Re: Indiana-Kentucky Electric Corporation
Clifty Creek Station's 2018 Annual Landfill Inspection

**Reference: 2018 CCR Rule Inspection
Annual Landfill Inspection
Clifty Creek Generating Station
Madison, Indiana**

**2018 CCR Rule Inspection
Clifty Creek Landfill**

Clifty Creek Generating Station
Madison, Indiana
Jefferson County

INITIAL CONSTRUCTION

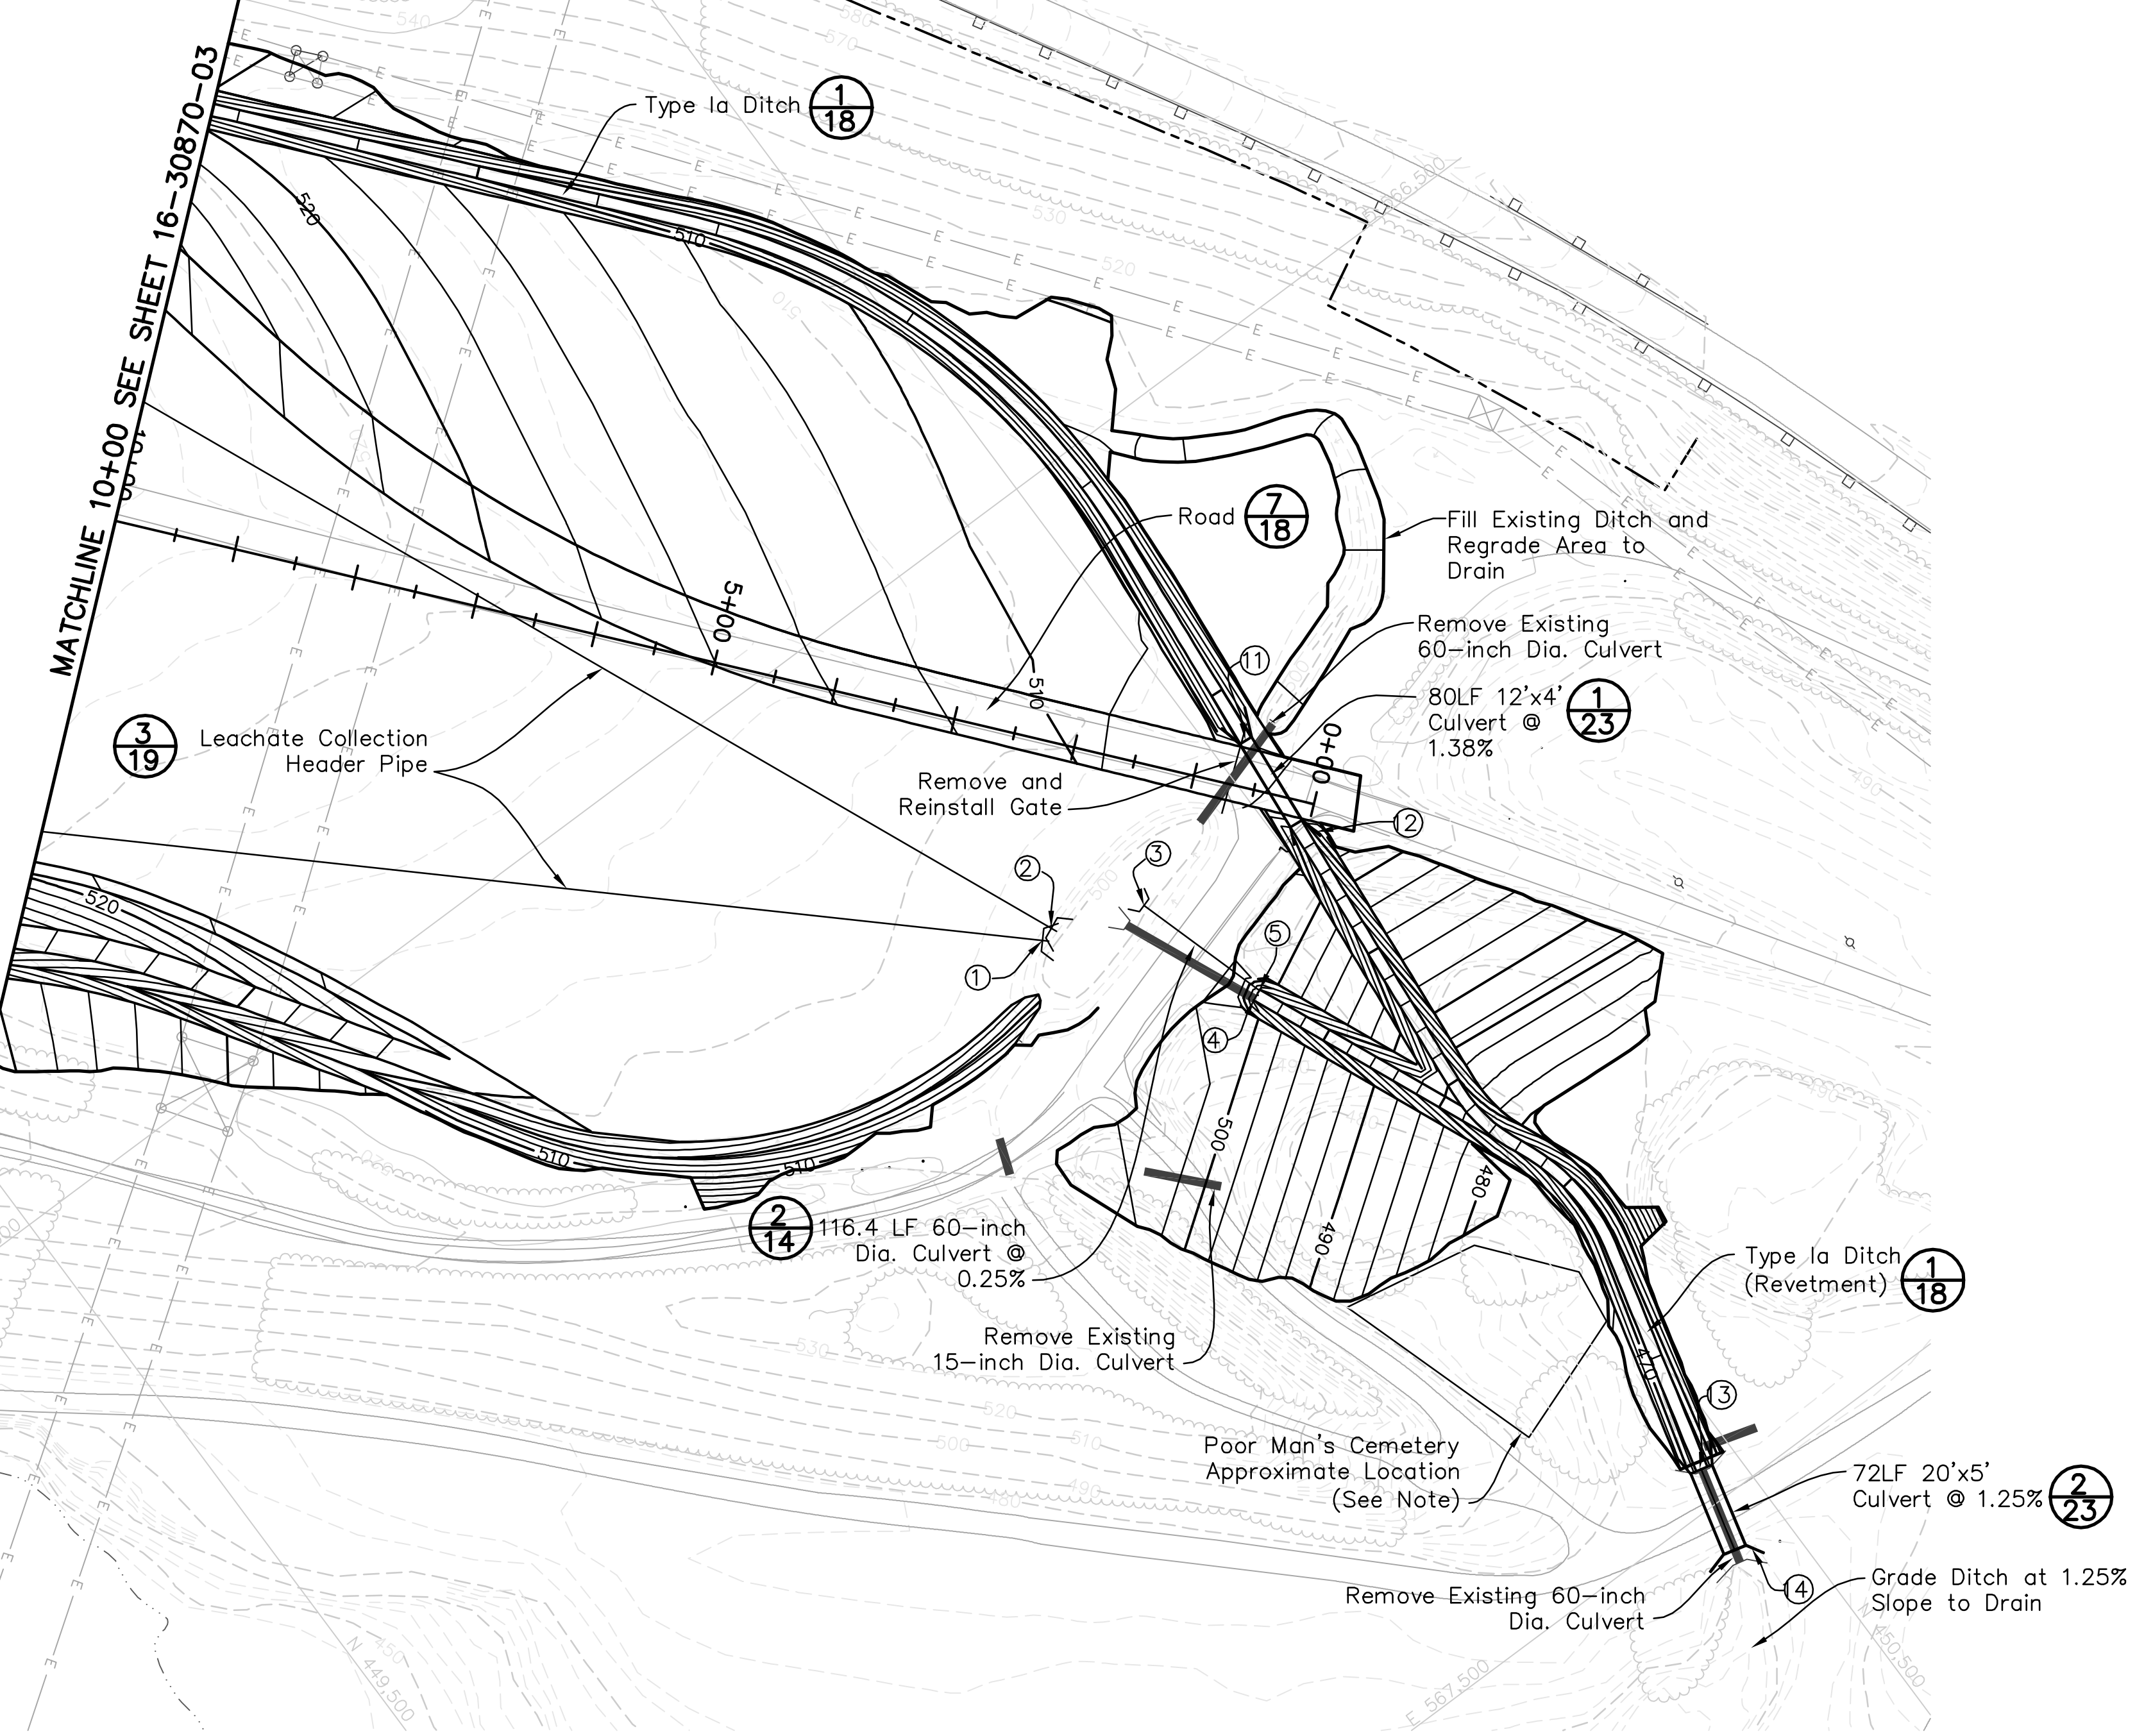
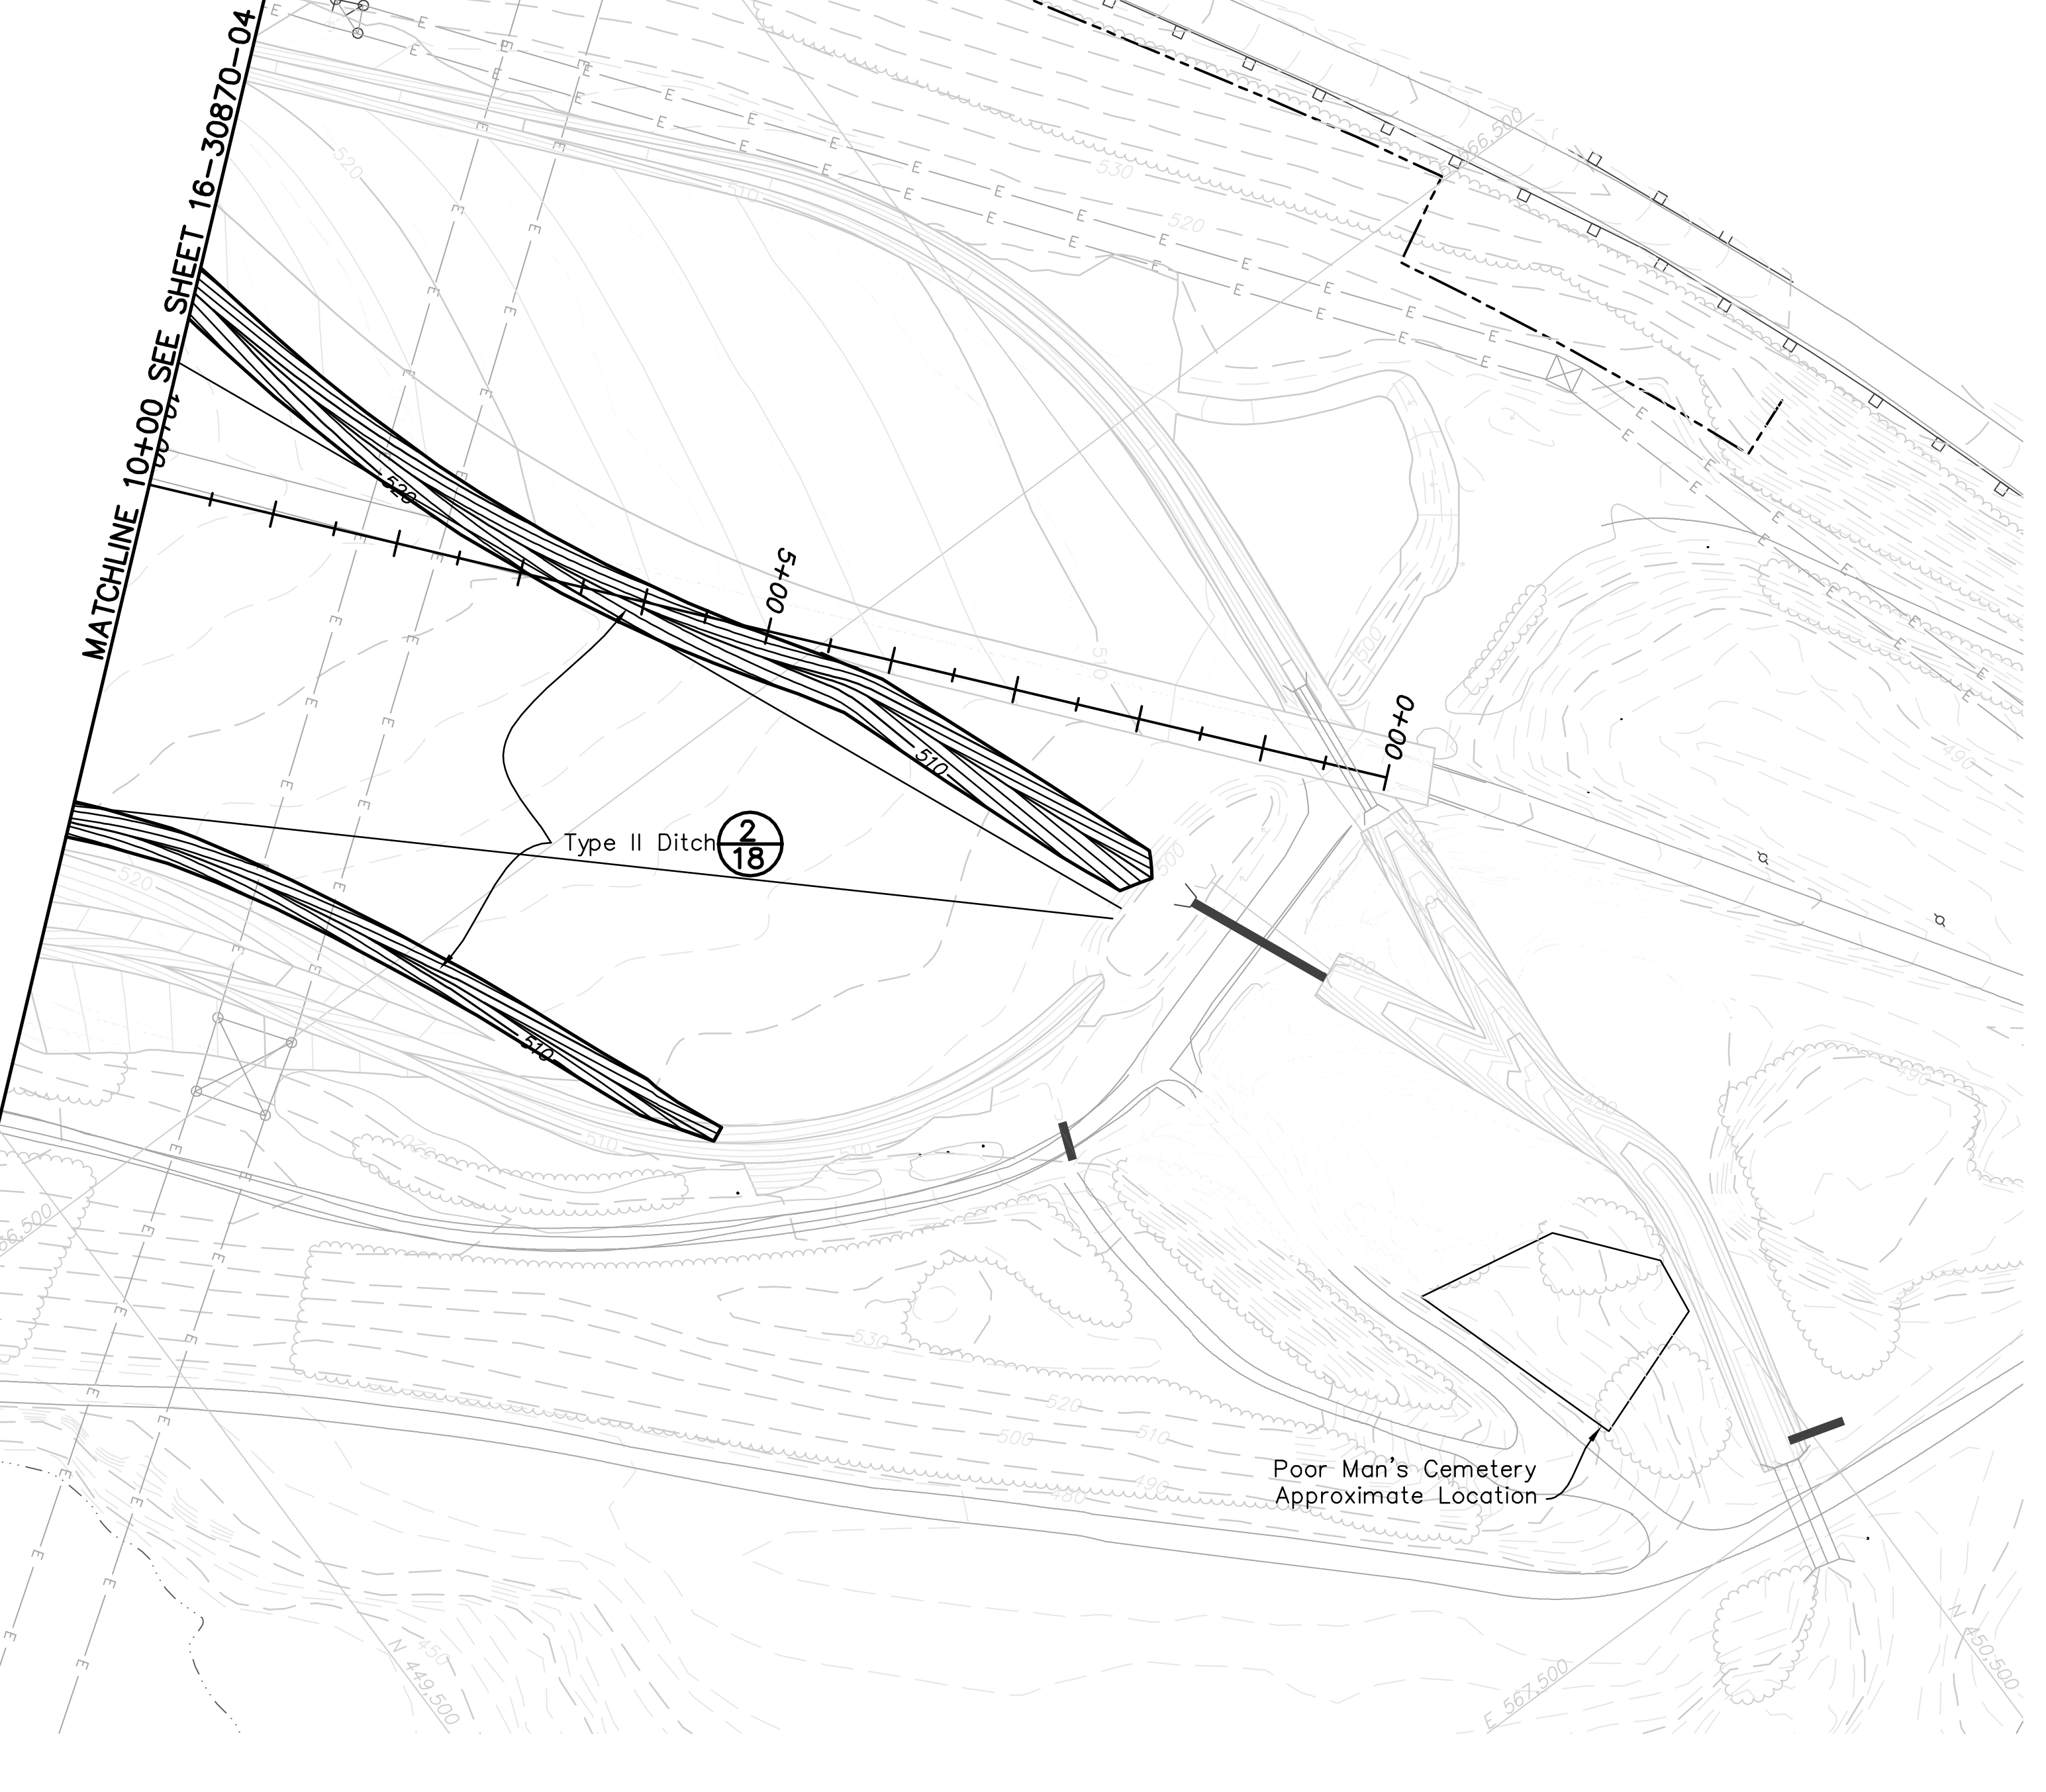
Four riprap-lined surface water channels are constructed east of the Type I active landfill. See reference Drawing No. 16-30870-05 in Appendix C, provided to clarify the four surface water channels observed east of the Type I landfill. The channels nearest the paved haul road and the natural southern ridge (Devil's Backbone) control flow from the surrounding watershed. The two channels in the middle are intended to manage stormwater flow once final cover is placed in Phase I. Flow from the four channels moves eastward to the West Boiler Slag Pond and its associated National Pollutant Discharge Elimination System (NPDES)-permitted outfall.

- CCR materials were not noted in the channel aside from backfill near the Conspan® headwall flowing into the West Boiler Slag Pond. The Conspan® is a precast concrete culvert and foundation represented on reference Drawing No. 16-30870-05 in Appendix C and is 72 feet long and 20 feet wide by 5 feet tall at a 1.25% slope.
